NFPA 1901/1906 Committee Meeting Highlights

Second Draft Meeting
Charlotte NC
July 22-24, 2014
Roger Lackore

1901 STANDARD FOR AUTOMOTIVE FIRE APPARATUS

Top Speed

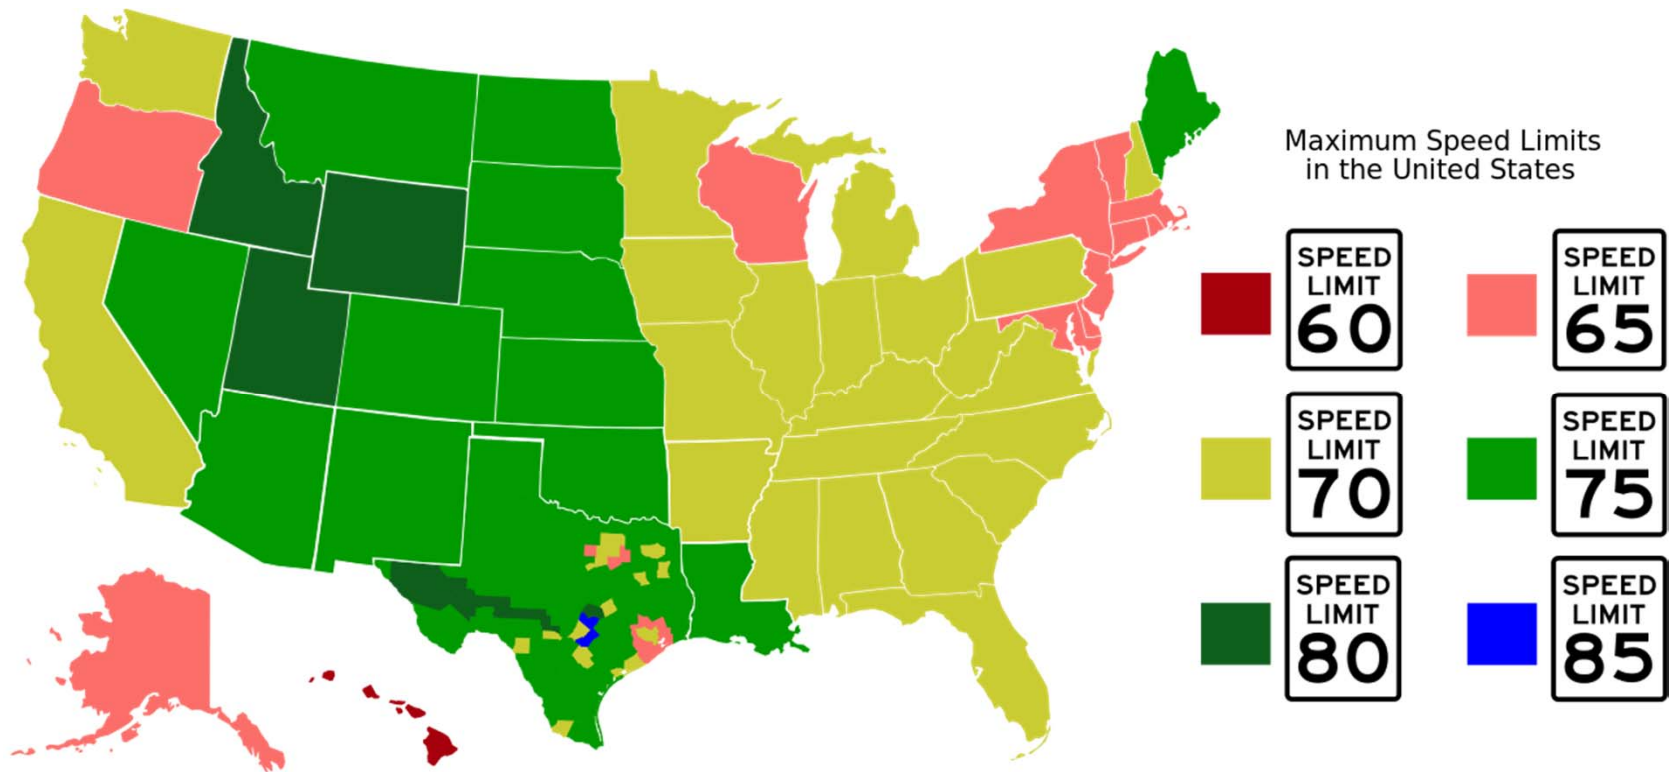
- 68 and 60 mph max speed limits retained.

Operator Manuals

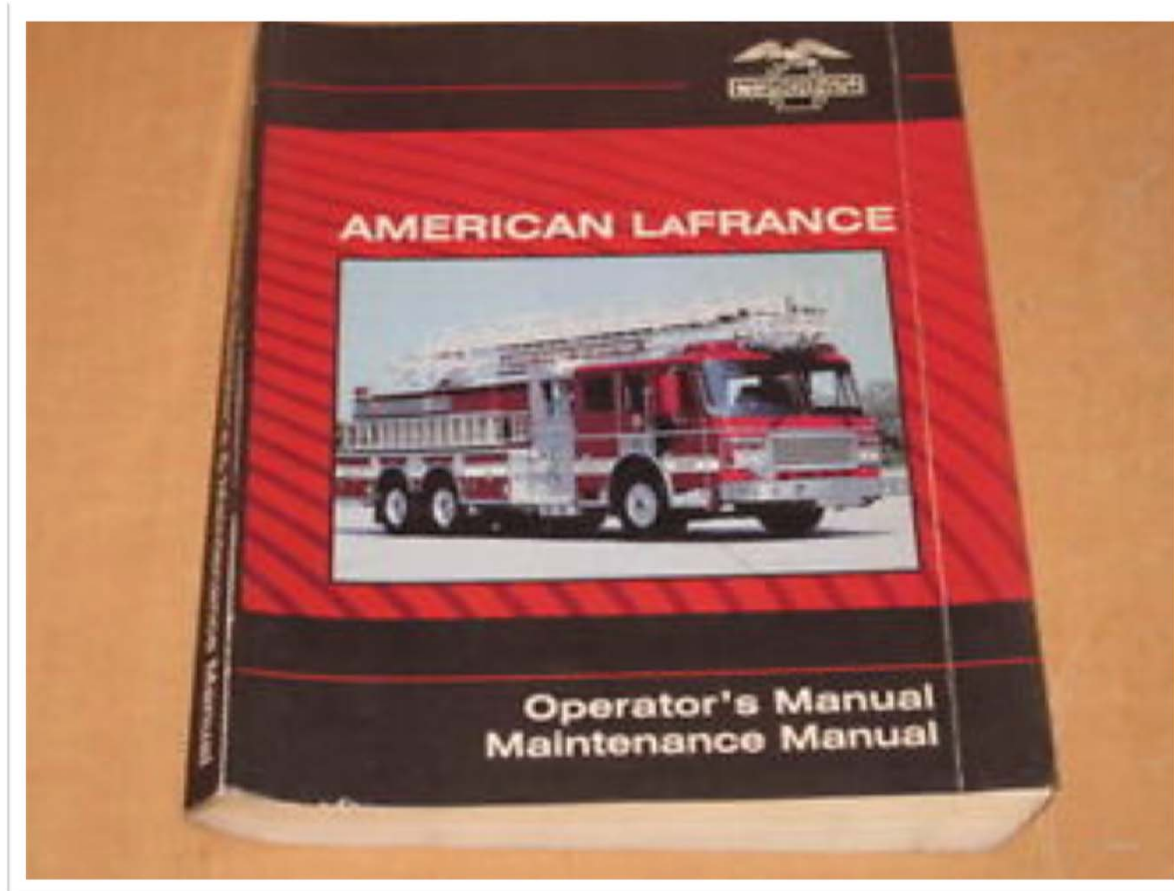
- Only one hard copy set required vs two.

FAMA Safety Signs

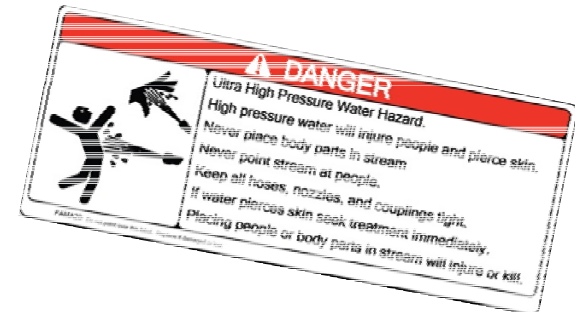
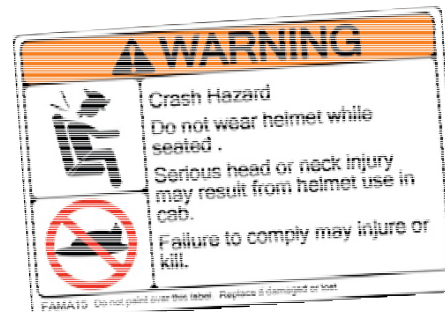
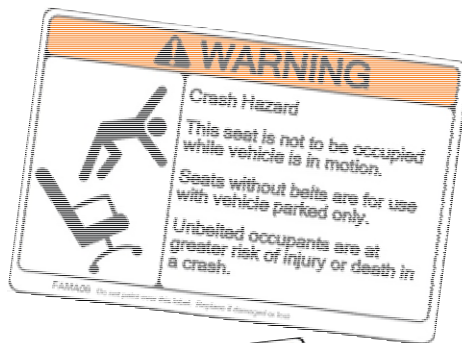
- Inclusion of many of the FAMA safety signs was confirmed, a few more added, and the specification wording simplified.

Step Toe Clearance

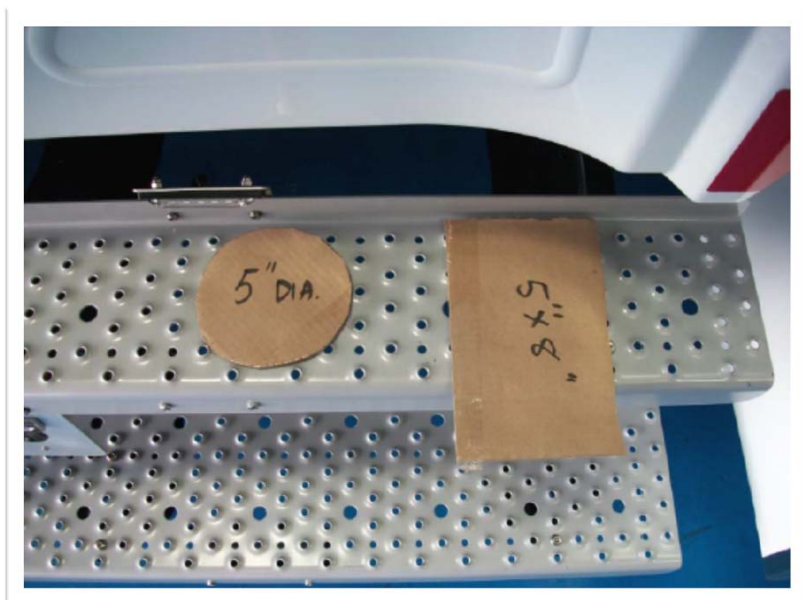
- Toe clearance reduced from 8 to 6 inches.

Tiller Cab Integrity

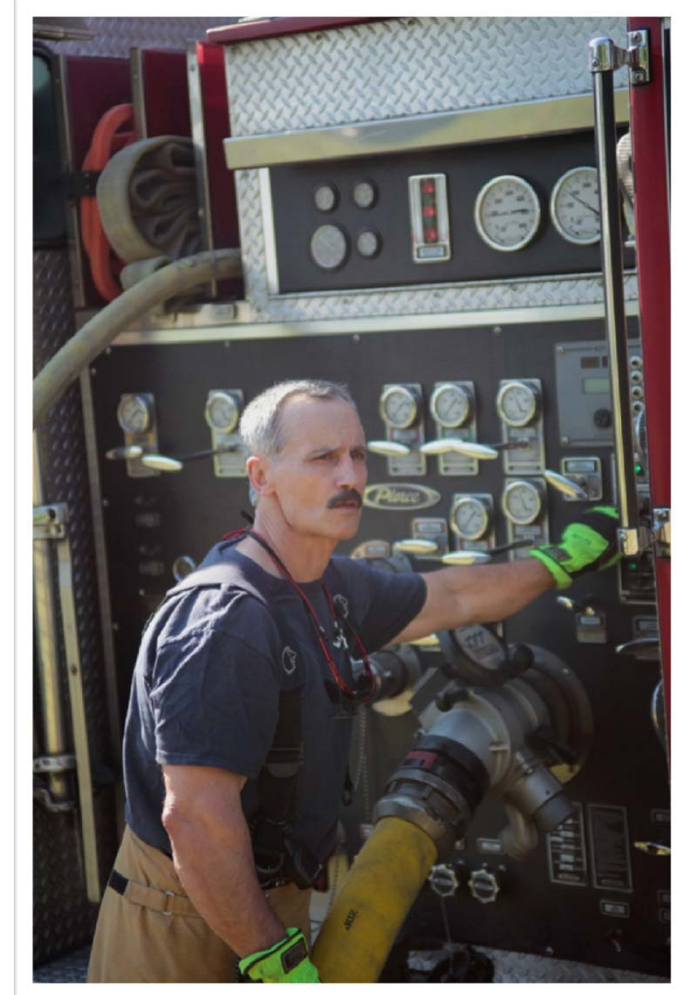
- Tiller cabs shall meet the requirements of SAE J2422, Cab Roof Strength Evaluation — Quasi-Static Loading Heavy Trucks

Aerial Platform Railing

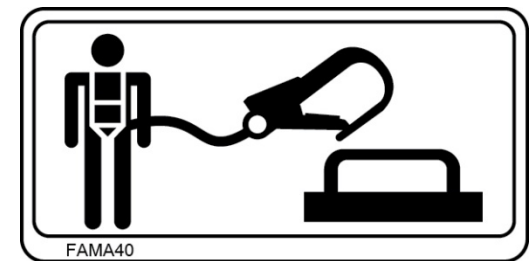
- The continuous guard railing shall be capable of withstanding a force of 225 lbf (1000 N) applied at any point from any direction without permanent deformation.
- Each gate shall be capable of withstanding a 1000 lb force (4000 N) applied at the least favorable position in the least favorable direction, without opening outward.

Crew Carrier Chapter

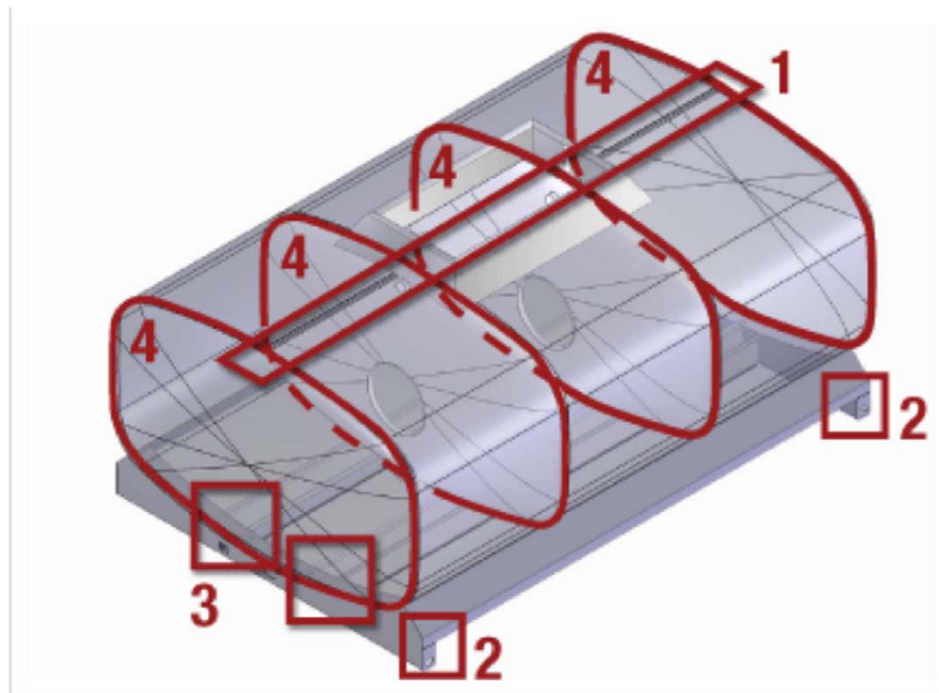
- New chapter defines a wildland crew carrier.
 - Seats & occupant restraints.
 - Doors
 - Structural Integrity
 - Means of Escape
